Exide Battery Plant Development

Community Feedback and Recommendations

Developed by Capitol View Neighborhood Association Development Committee

Neighborhood Recommendation: Land Use

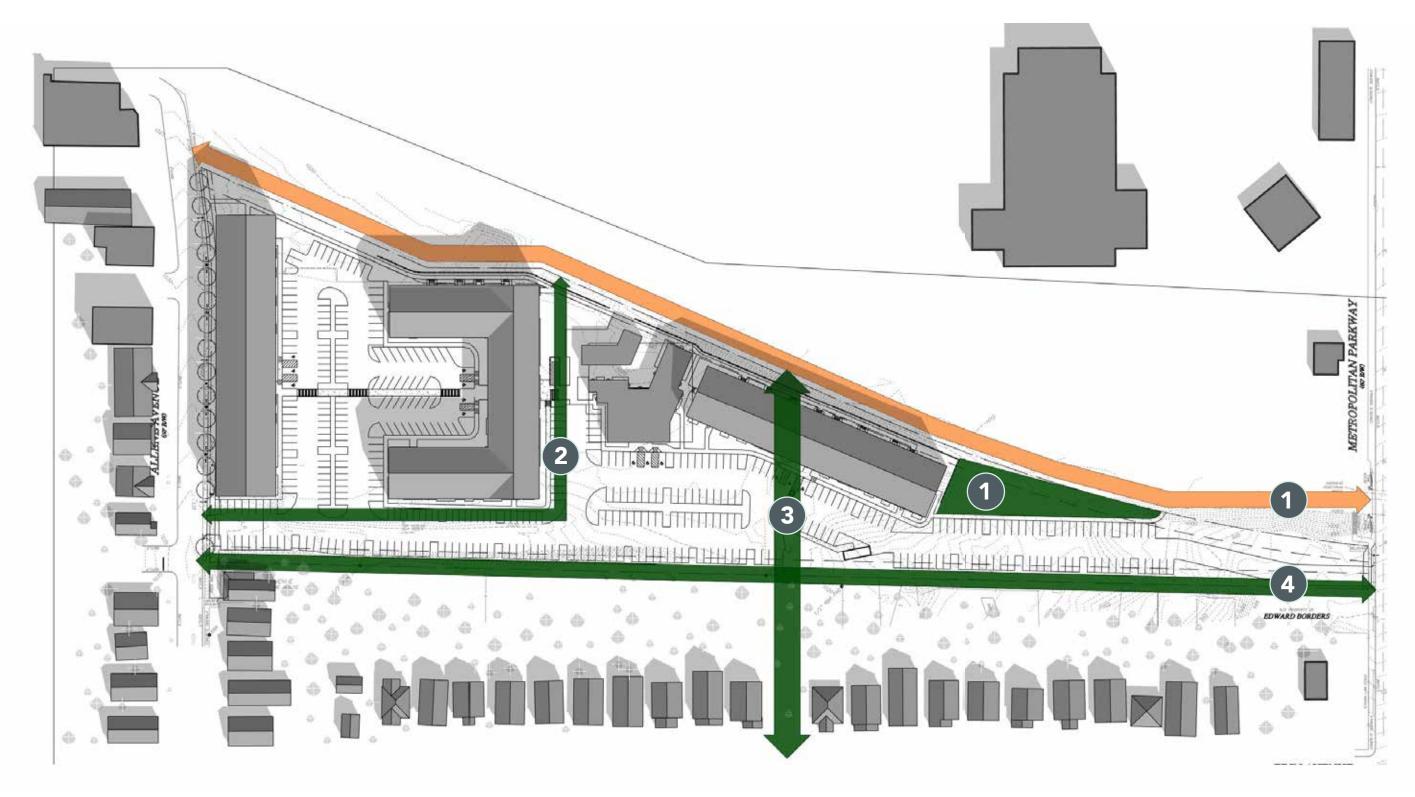
Rangewater has expressed an awareness that as Atlanta grows in the coming years, there will be a need for greater density, particularly around the Beltline, which was formed for the explicit purpose of connecting the city through walkability, bicycle infrastructure, and eventually, transit. This greater density, paired with these alternate modes of transportation will create an opportunity to reinvision this development in coming years as Atlanta grows.

To that end, we recommend that the development should prioritize adaptability through an emphasis on mixed use. While the current zoning has a focus on residential, there is no reason that the first floor of the buildings cannot be built to allow for a change to commercial or retail use in the future, as demand for those uses increases. They could be built as flexible live-work spaces, for instance. This emphasis on adaptability would ultimately make the development more desirable and resilient, as it would expand the possibilities for future use. We ultimately want the development to be as successful as possible, and we believe that to limit the development's use to strictly residential would severely limit that success.

We believe the development should also prioritize the adaptability of its surface parking. In a community meeting, Rangewater acknowledged that there may be a demand to repurpose the surface parking of this site in coming years as the demand for density increases. Unfortunately, the plans as presented offer little opportunity to repurpose the extensive surface parking. One parking lot is almost completely surrounded by buildings, which would make future redevelopment of that spot nearly impossible. The rest of the parking is spread out over a narrow slice along the south of the property, such that development of that area would necessarily cut off traffic routes across the site. As presented, it's hard to imagine repurposing much of the parking without significantly hindering the use of the existing buildings. We recommend that the entire layout of the buildings and parking lots should be changed to allow the maximum amount of flexibility for future development. There should be a plan envisioned for parts of the parking lot to be redeveloped, without impeding the parking that is left.

Beltline Access

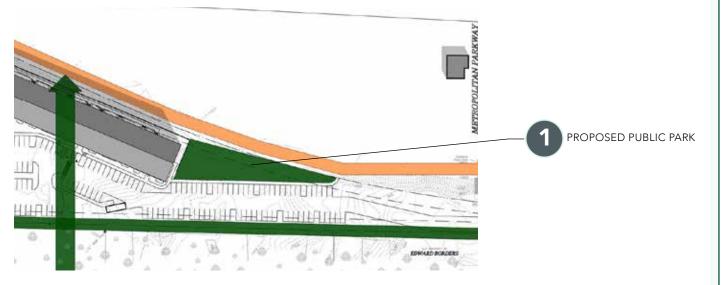
- The project site parcel stretches across the entirety of Capitol View neighborhood's direct beltline access. The plans presented by Rangewater displayed conflicting design elements regarding public beltline access through their project, making it difficult to understand what their plan is. We understand that Rangewater plans to build a ramp from the sidewalk on Metropolitan Ave south of the existing rail bridge, sloping up to the Beltline. It is our understanding that this ramp would be available to the public. We appreciate this feature of the design, and want to emphasize that such an access path should be wide enough for comfortable mixing of pedestrians and bikes in both directions, and that it will also be graded to ADA standards for manual wheelchair access. On at least one site plan provided Rangewater proposed a private dog park on a triangular sliver of land abutting the BeltLine. We recommend that Rangewater work with the Beltline to instead transform this sliver of land, which runs alongside the public use access ramp from Metropolitan, into a pocket park available for public use. In addition to signaling a gesture of goodwill to neighbors whose entire beltline frontage is otherwise occupied with this development, doing so would better transition the public access into the BeltLine trail itself.

- The proposed site plans also represented various versions of pedestrian access through and across parking lots. At least one version of the plan did not even include crosswalks where pedestrians would need to cross a parking lot thoroughfare in order to access the BeltLine. We recommend that the development include protected pedestrian and bike access from the southern face of the Allene Avenue building through the site to the commercial space identified as a potential coffee shop and to the BeltLine, directly. We also recommend that Rangewater include proper pedestrian-oriented way-finding signage through their property to clearly demonstrate that the access pathways are intended for public use.

- A Capitol View resident whose property abuts the development has expressed interest in working with Rangewater and the BeltLine to create interior neighborhood access to the BeltLine. We hope that Rangewater will take this unique opportunity to explore the possibility of creating access from Erin Avenue across the site plan to the Beltline. Please contact the Capitol View Neighborhood Association [info@capitolview.org] to get in touch with the neighbor who has expressed interest in exploring this possibility.

Through Street Connection

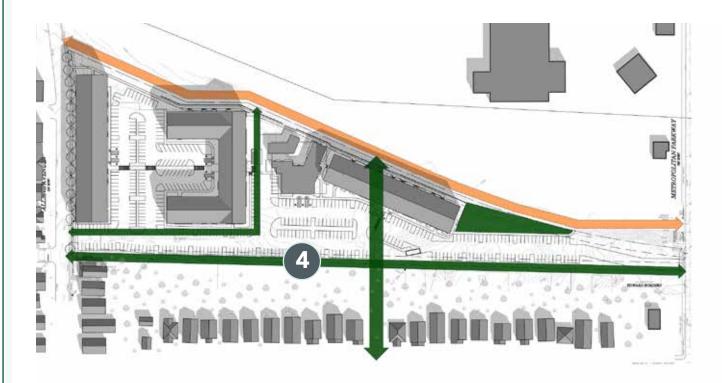
We highly and strongly recommend that a new two-way street/pass through be created to connect Allene Avenue with Metropolitan Parkway. Effectively an extension of Beechwood Avenue, this would maintain and extend the existing grid of the Capitol View neighborhood. The entrance into the apartment complex could be moved from Allene onto this street allowing new options on site configurations.

In addition, the proposed roadway could could be conceived to incorporate public angled or head in parking on its Northern side to supplant on-site parking given over to this purpose, which will mitigate parking overflow into the already densely-parked Allene Avenue and Erin Avenue.
